UNITED STATES PATENT AND TRADEMARK OFFICE

APPLICATION NO.	FILING DATE	FIRST NAMED INVENTOR	ATTORNEY DOCKET NO.	CONFIRMATION NO.
10/043,653	01/09/2002	James F. Robertson	015490-000000US	6028

Office Action Summary	Application No.	Applicant(s)	
	10/043,653	ROBERTSON, JAMES F.	
	Examiner	Art Unit	
	Tony G Soohoo	1723

DETAILED ACTION

MARK UP OF MOORE PATENT (fig 1) and Application drawing (fig 2)

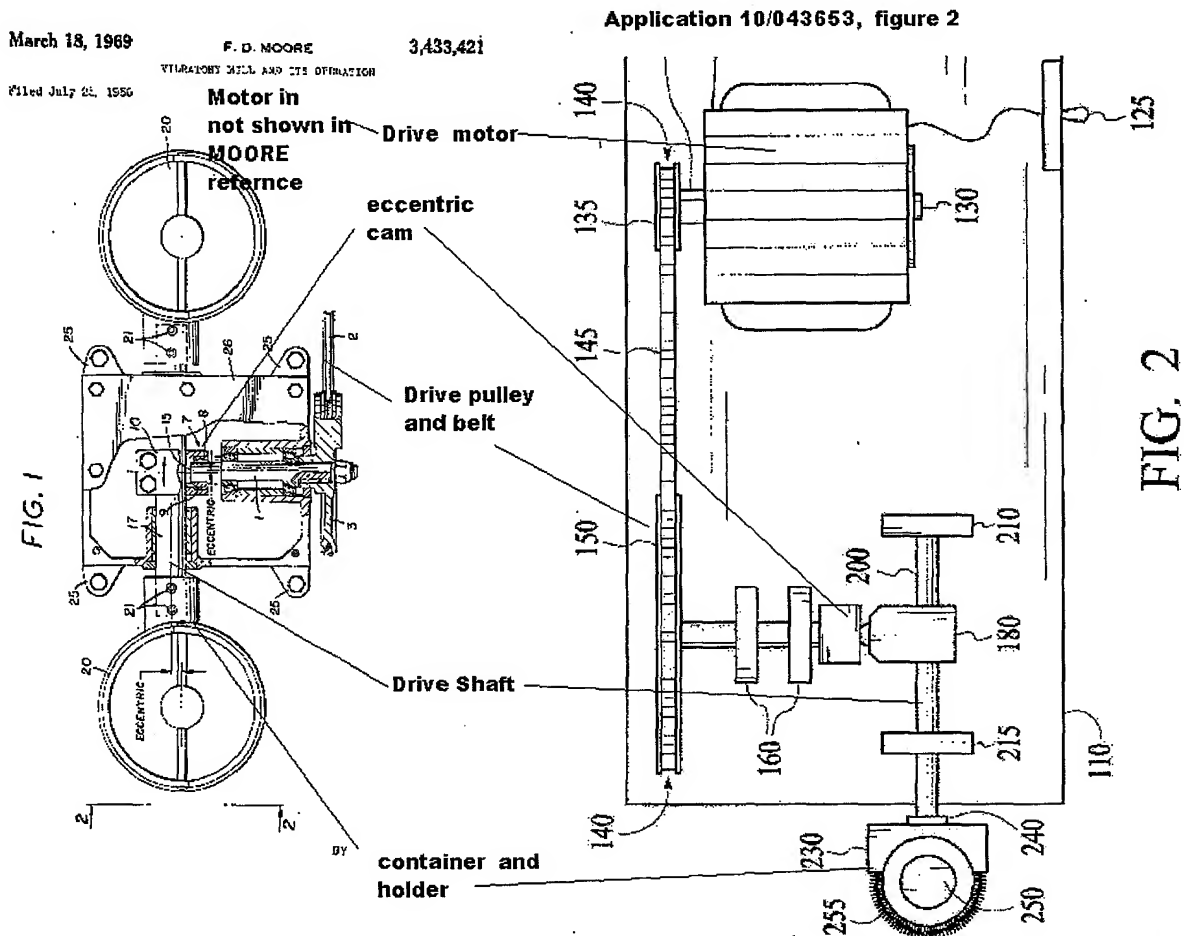
2. Claims 1-20 are rejected under 35 U.S.C. 103(a) as being unpatentable over Moore 3433421 in view of Miller 4497581.

Moore discloses a belt drive, an eccentric drive cam, a container holder, a drive shaft coupled to the drive cam and container holder and the corresponding manner of operation and agitating a material in the container.

Moore discloses all of the recited subject matter as defined within the scope of the claims with the exception of a drive motor connected to the drive pulley and drive belt the manner in which the belt is driven is not shown.

The reference to Miller teaches that a driven shaking device may be provided with a motor and motor shaft 46a and motor shaft pulley 48 a connecting belt 50 in connection to a rotating shaft pulley 52 to provide an appropriate drive forces from the motor shaft to the rotation shaft 42, see figure 5.

In view of the teaching of Miller that a motor with motor shaft, and motor pulley may be provided to drive a belt to rotate a rotating shaft and pulley, it is deemed that it would have been obvious to one of ordinary skill in the art to provide with the device of

Moore with a motor device and corresponding pulley to move the drive shaft in an appropriate rotational and vibratory speed.
